MEMORANDUM REVISED

Project: The Grove At Shoal
Creek

Re: Review Comments

The Grove at Shoal Creek Planned Unit Development

Figure 2.5: PUD Land Use Plan

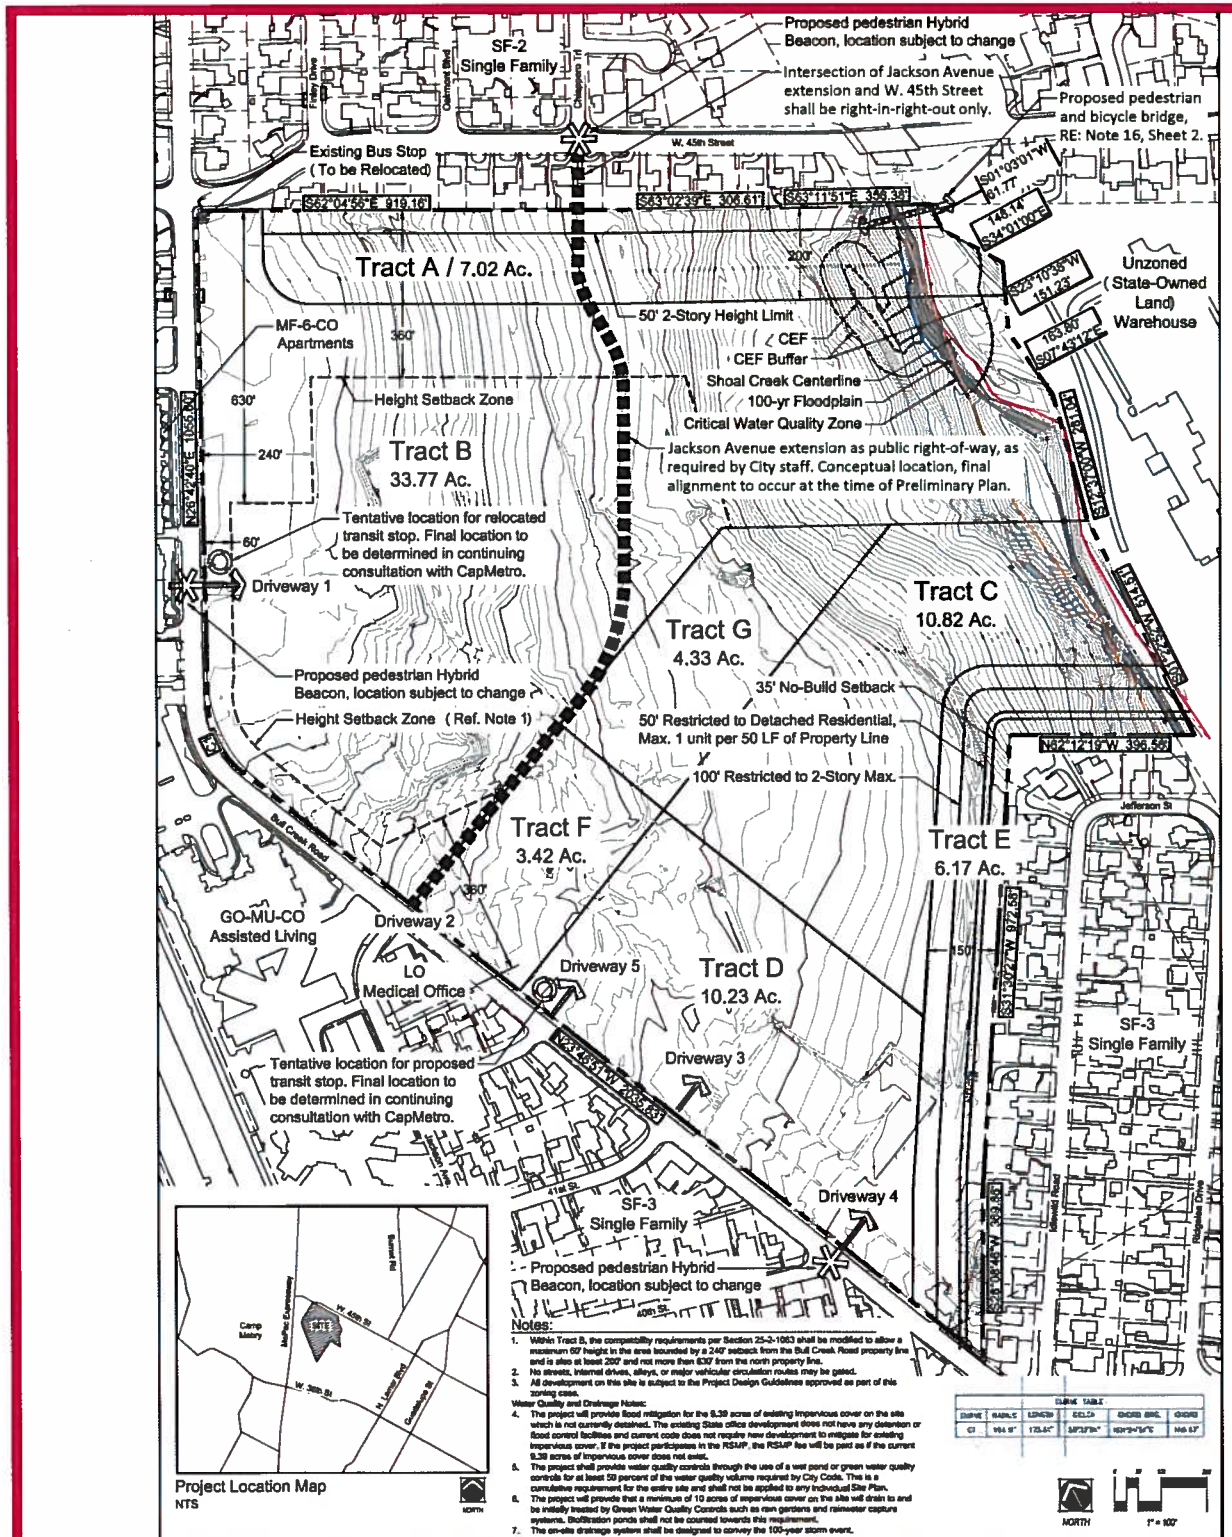
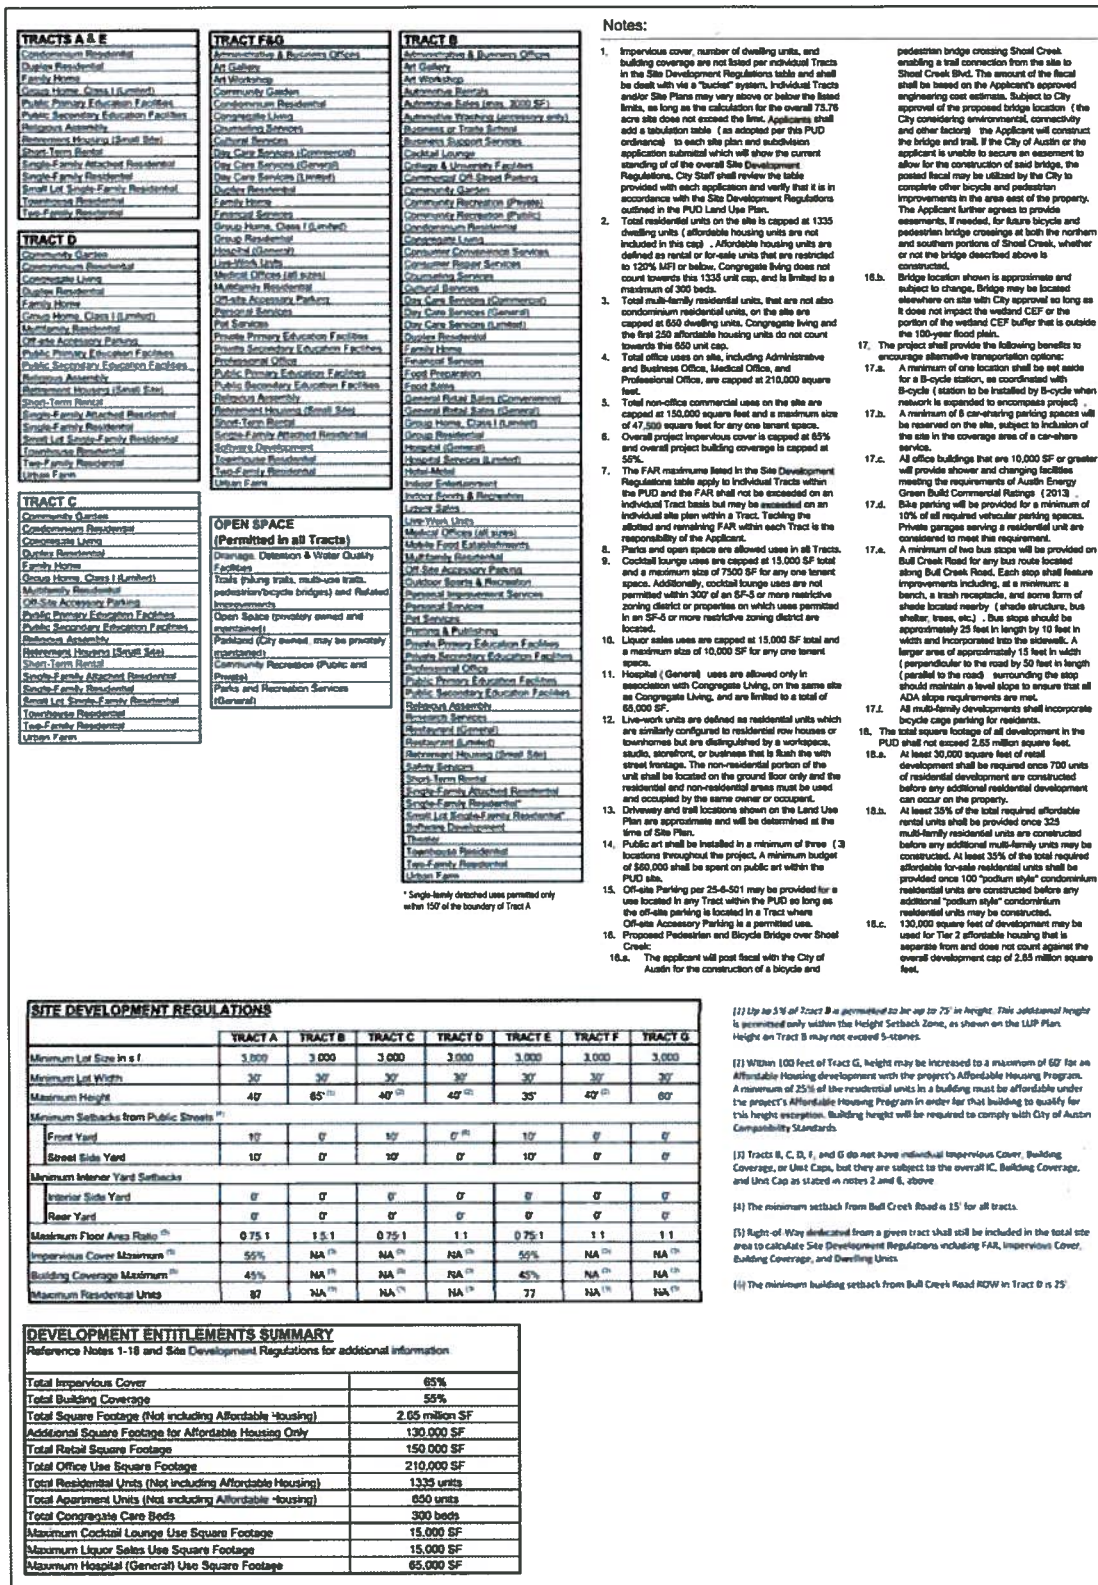
3. The PUD Land Use Plan (Figures 2.5 and 2.5.1 on pages 9 and 10) has been updated with the new sheets. *(Clarification)*
4. The Master Framework Plan (Figure 3.3 on page 13) has been updated to reflect the new Jackson Avenue alignment. *(Clarification)*

Figure 3.4.1: Bull Creek Road

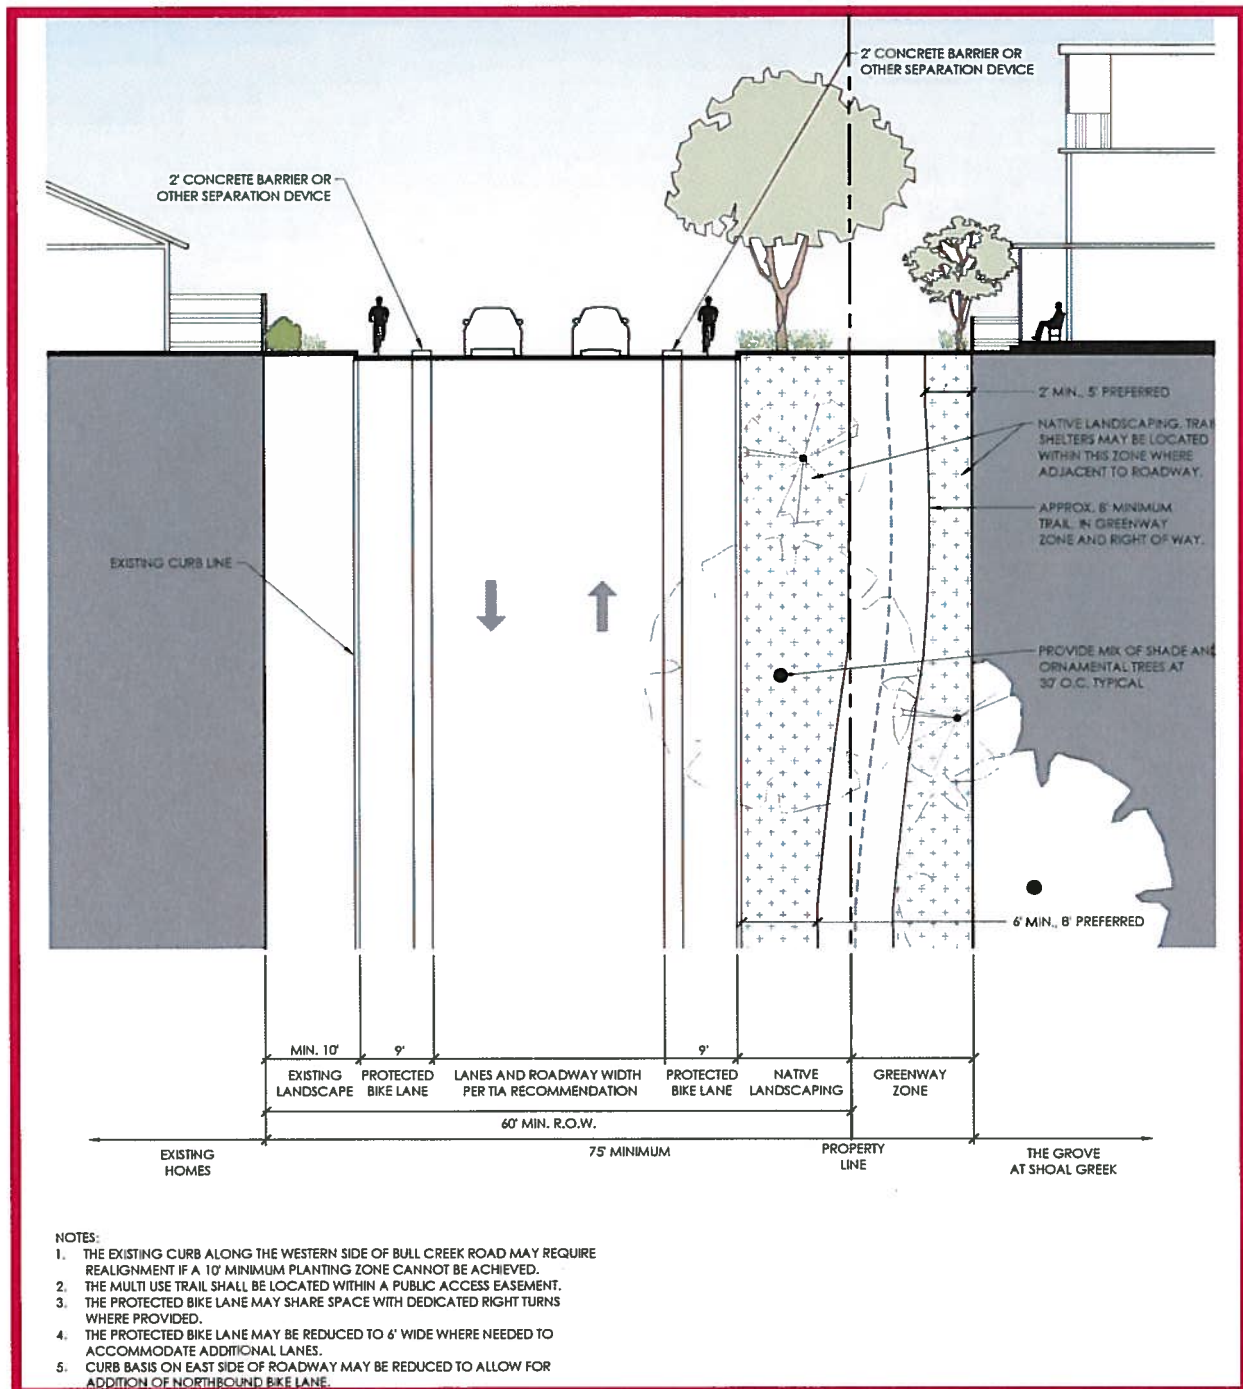
5. The Bull Creek Road section (Figure 3.4.1 on page 14) has been updated to include a northbound bike lane. *(ZAP Recommendation)*
6. The Retail Main Street section (Figure 3.4.2a on page 15) has been updated to allow for alternative parking configurations. *(Per meeting with City Staff on 8/9/16)*

Figure 3.4.2.b: Retail Main Street - Parkway Alternative

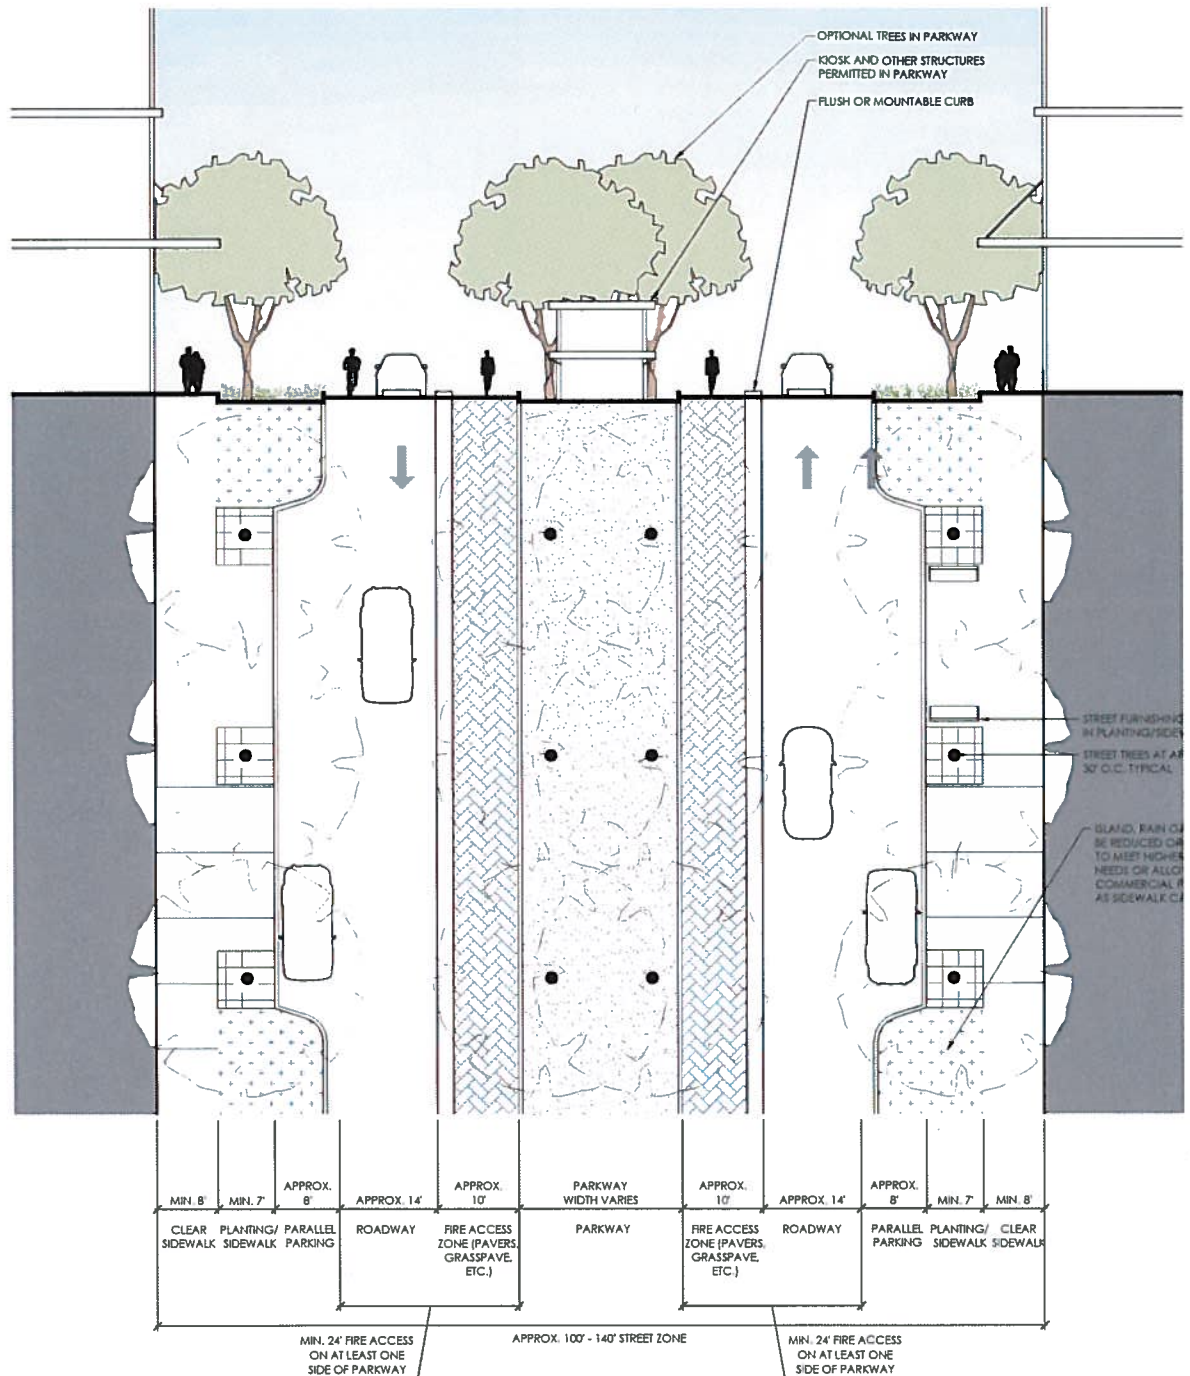
7. An alternative Retail Main Street section (Figure 3.4.2b on page 16) has been added to allow for a potential parkway configuration. *(Per meeting with City Staff on 8/9/16)*

Figure 3.5.8: Slip Road

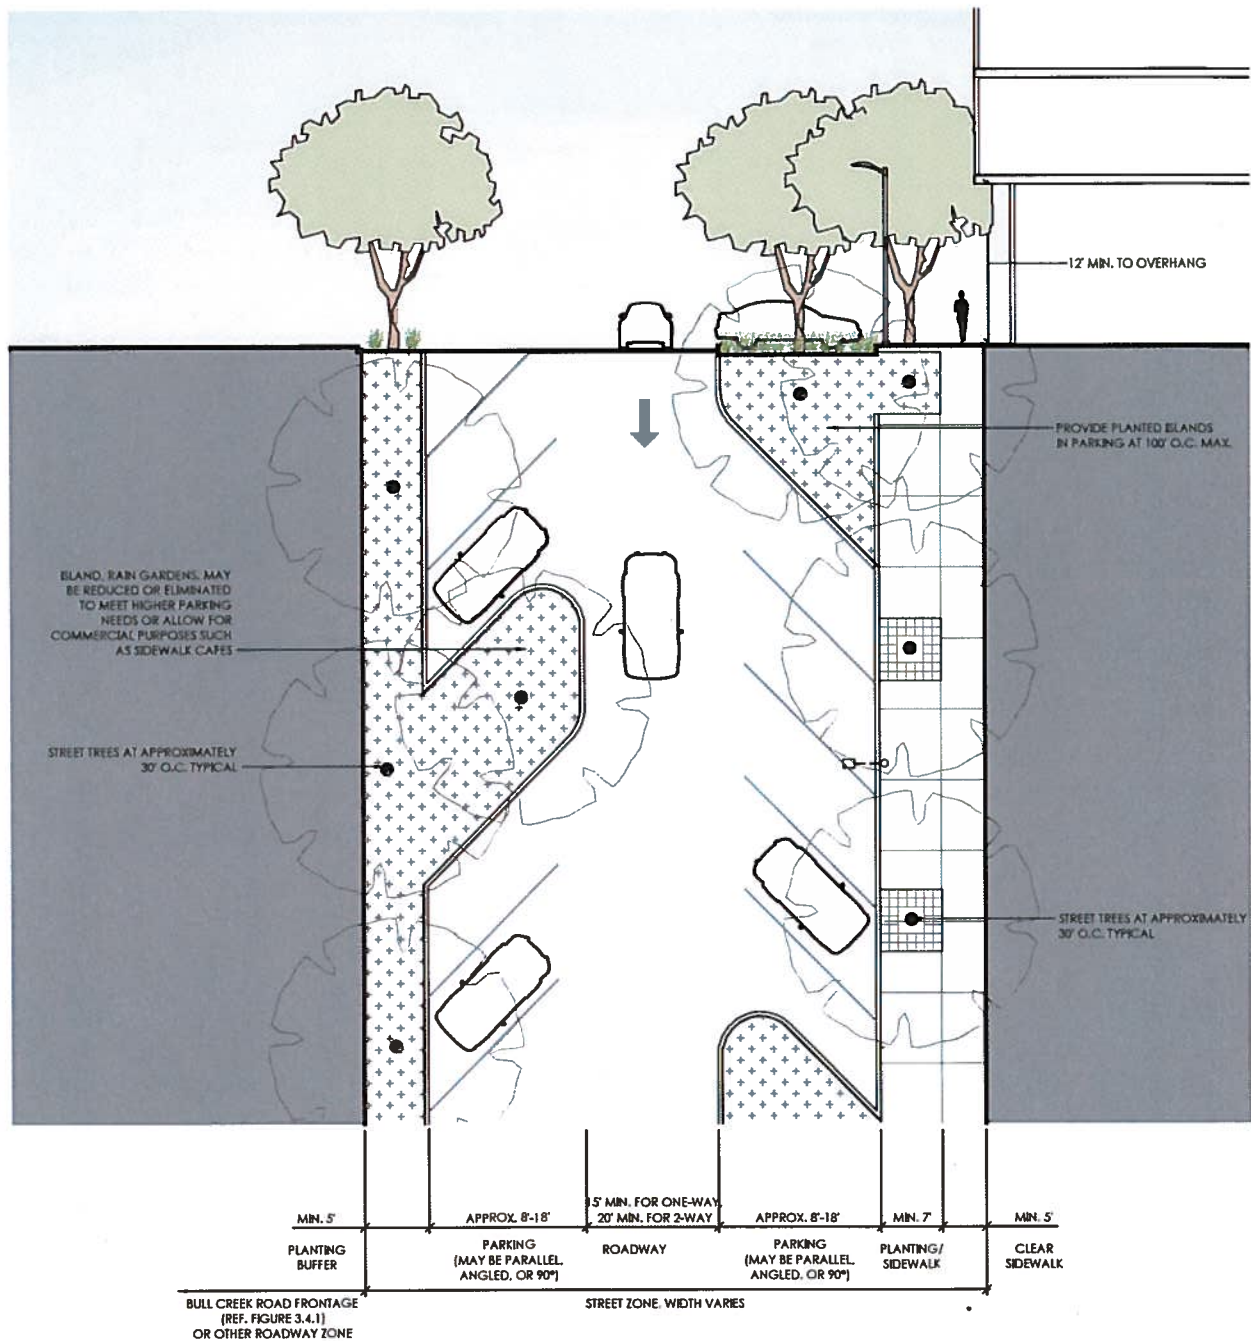
8. An additional street section (Figure 3.5.8 on page 25) has been added to allow for a slip road. *(Per meeting with City Staff on 8/9/16)*
9. Section 3.6.2 regarding Typical Traffic Circles has been updated to clarify language and note that this is an optional facility. *(Clarification)*

Figure 4.4.3: Residential Development on Parks

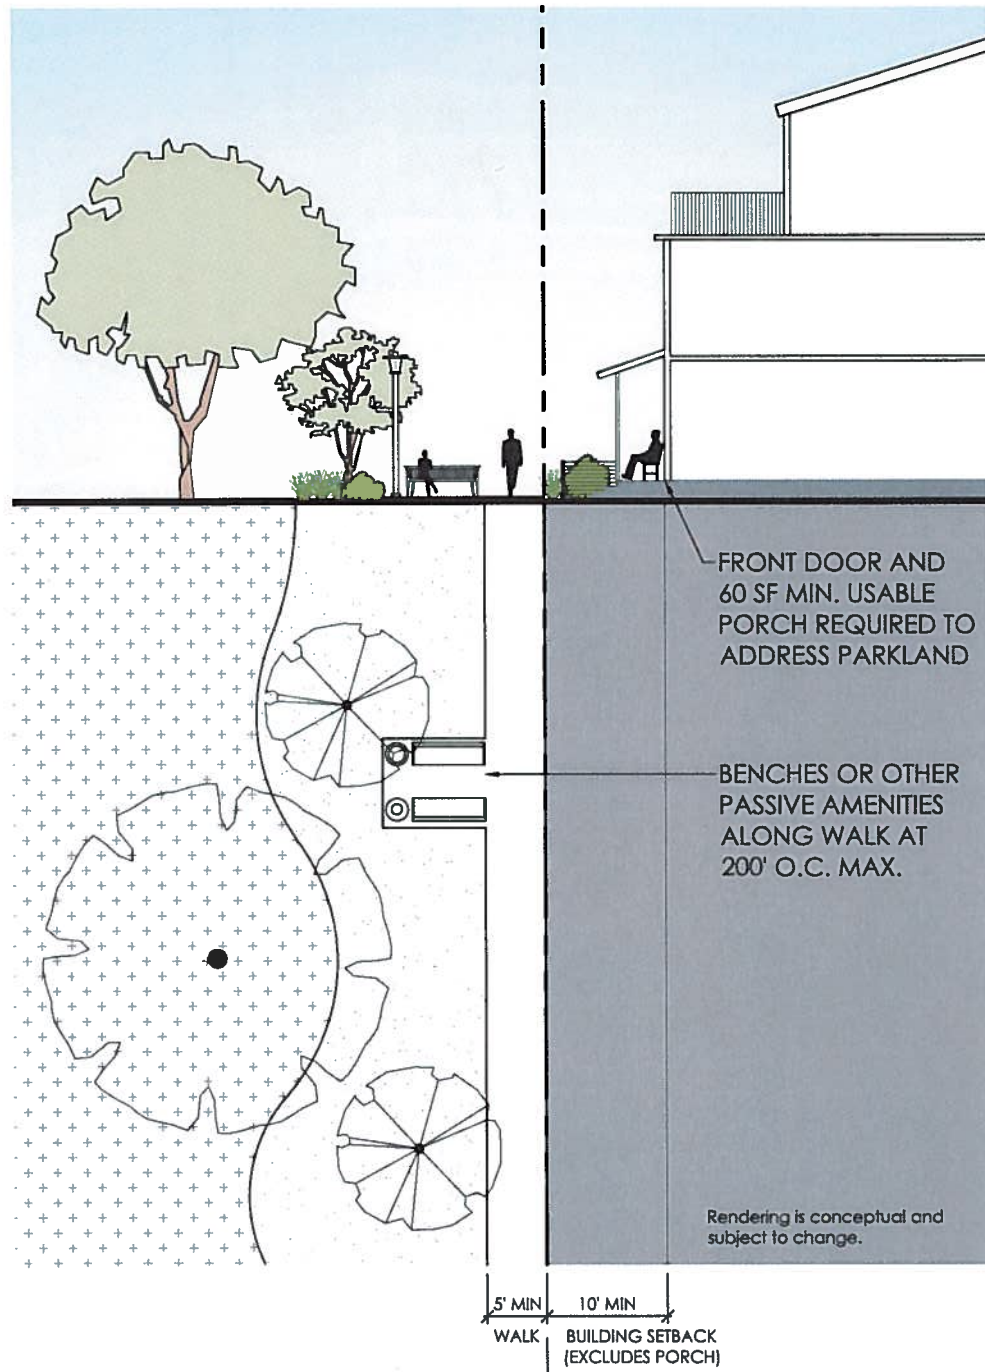
14. Section 4.4.2(e)(5) has been added to clarify that glazing requirements do not apply to parking structures. *(Clarification)*
15. Section 4.4.3(c) and Figure 4.4.3 have been added to govern residential development adjacent to parks. *(Condition of PARD Superiority)*
